Comment on Eversource's application to the Town of Easton for a Conditional Use Permit re Easton's Steep Slopes zoning. I incorporate by reference comments on Eversource's structure height Variance and Wetlands and Site Plan Review Conditional Use Permit applications where these contain the same text and maps.

Comment to SEC 2024-02, DE-24-087, Easton Planning Board and Easton
January 15, 2025

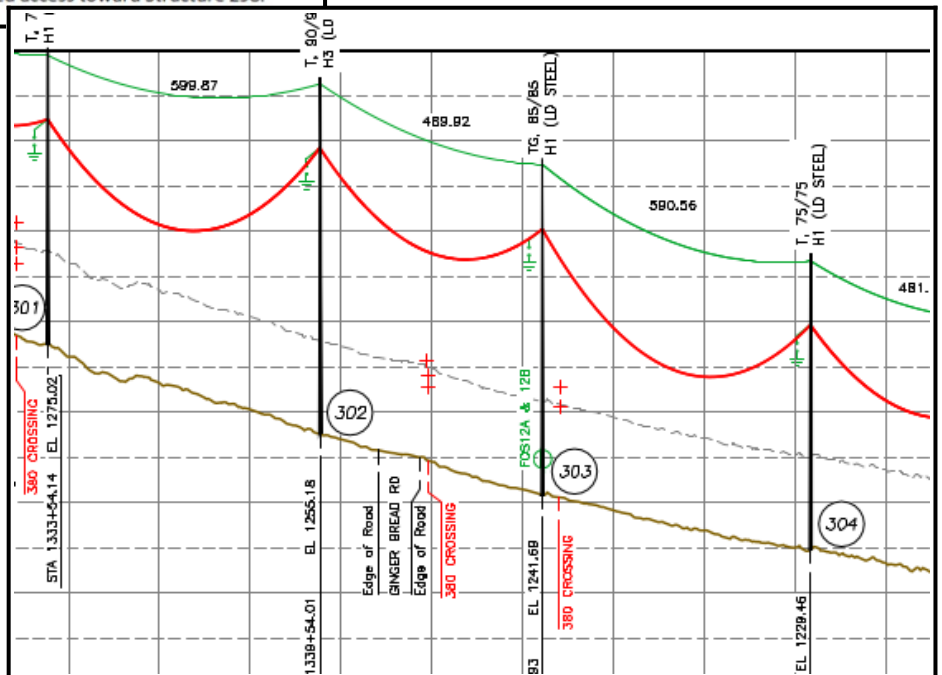
How does this work with Eversource's waiver from DES 1503.21(d)(6&7) which allows it to move the road anywhere in the cleared easement?

"RE: X178-2 Transmission Line Rebuild and OPGW Project, Phase 1 Permit: AoT-2597 Woodstock, Easton, Sugar Hill, NH Dear Applicant: Based upon the plans and application, approved on May 28, 2024, we are hereby issuing RSA 485-A:17 Alteration of Terrain Permit AoT-2597. As part of the processing of this application, DES granted approval to waiving specific requirements of Env-Wq 1503.12(d)(1 & 2), Env-Wq 1503.21(d)(6 & 7), and Env-Wq 1504.09, finding that granting the waivers would not have an adverse impact on the environment, public health, public safety, or abutting properties, and that granting the requests is consistent with the intent and purpose of the rules waived." [p. 145](#)

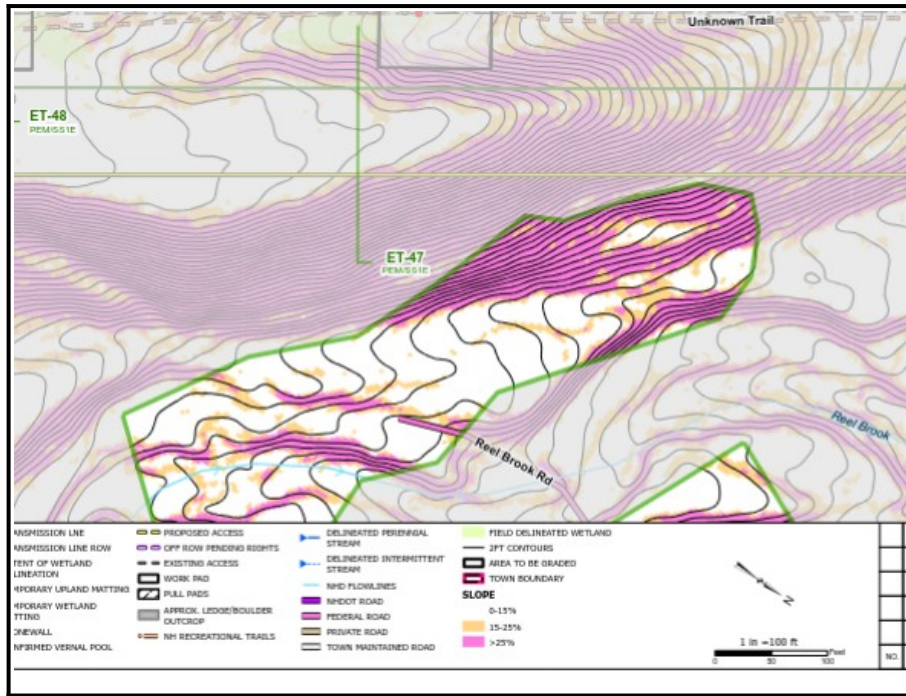
*"Proposed Alternative Allow for the access road centerlines to be relocated during construction, if necessary, up to a distance equal to the approximate width of the ROW (approximately 170-350 feet on the X178-2 Line). Shifts would not create greater than 5% increase in disturbed area along the individual access segment, which is assumed to be the length of the access road between two work pads/structures. **Allow for the center point of the parking area, assumed to be the structure replacement work pads for transmission line projects, to be relocated during construction, if necessary, up to a distance equal to half the approximate width of the ROW (approximately 170-350 feet on the X178-2 Line). Shifts would not create greater than 5% increase in disturbed area at each work pad.**" [p. 301](#)*

Note that Eversource plans to use the construction “pads” for parking, in contradiction to its Site Plan Review application denial of this intent: “...the project does not include uses such as public roads and parking lots...” p. 7

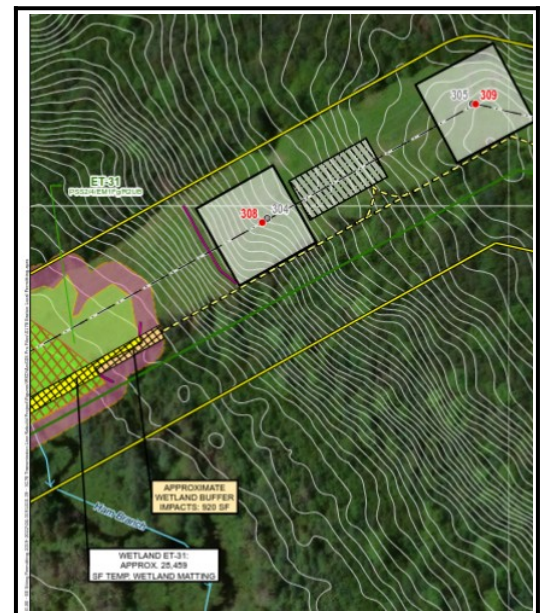
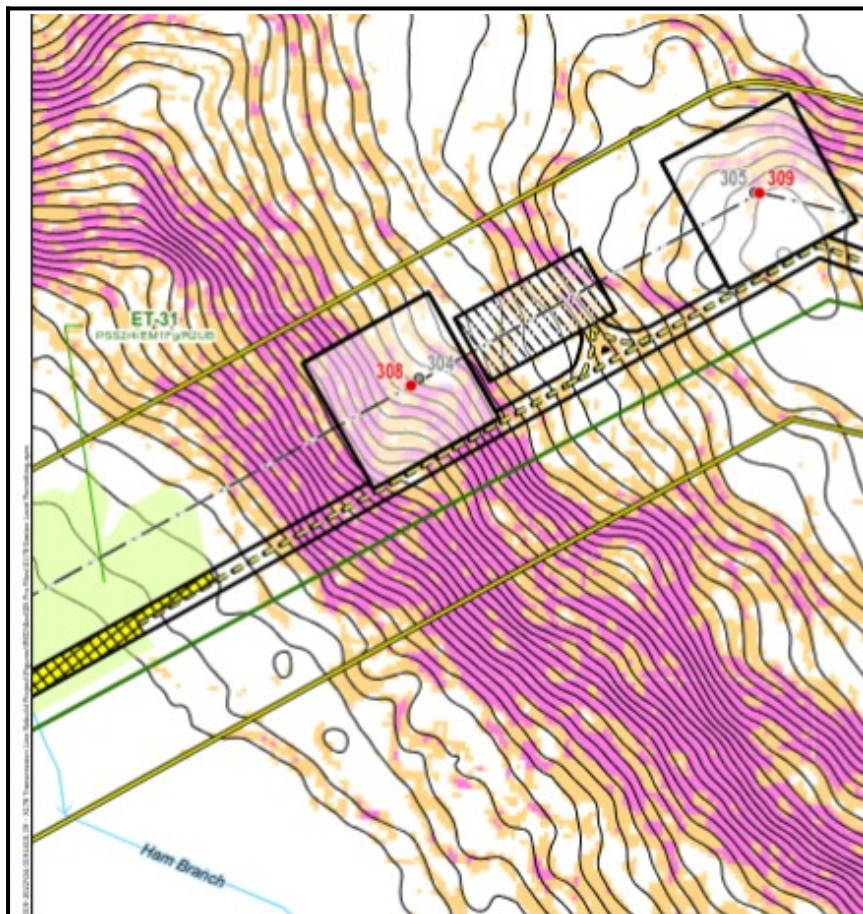
Eversource has made no changes in its “proposed” structure heights. Below, Gingerbread Village, existing structure 49’, proposed structure 79’. There is a house just left of this structure. Has Eversource contacted this landowner and discussed how the 30’ increase in the height of this structure could be reduced, for example by not exceeding the required clearance by 20’?

298 = 302 in the profile shown below.

The Steep Slopes map has the wrong parcel outline for the house and land at the end of Reel Brook Road, and no owner information for any of the lots except WMNF.

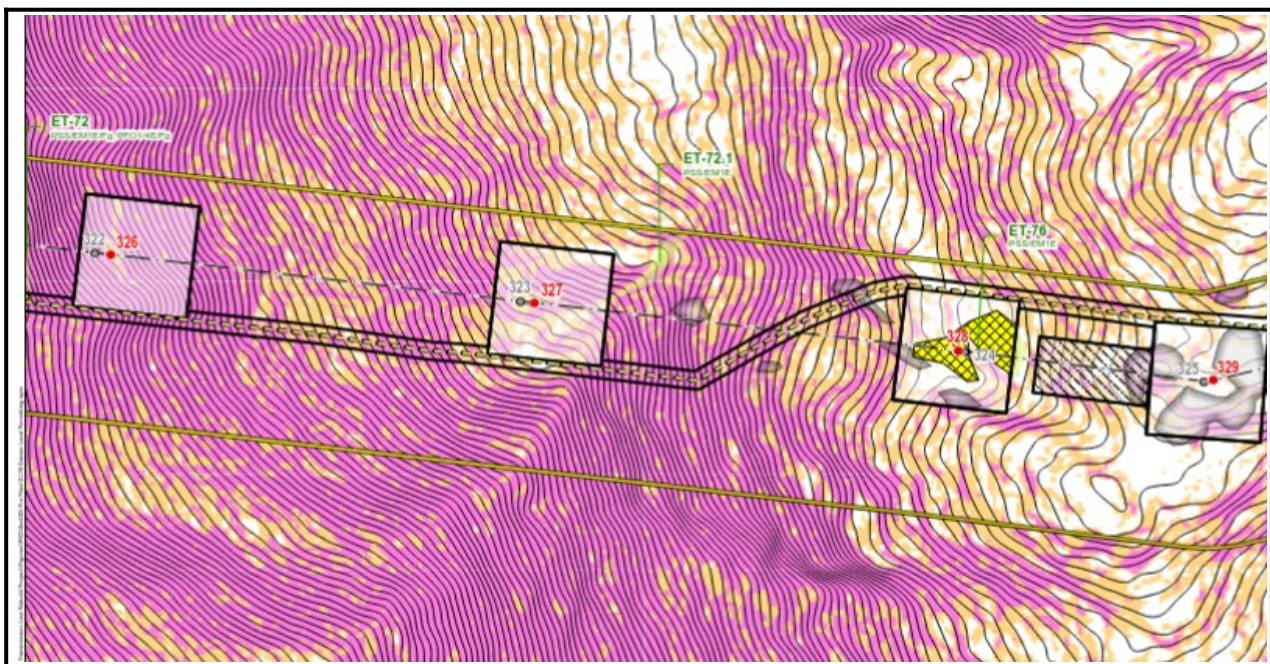
White Mountain National Forest boundaries are inaccurate on the Steep Slopes map.
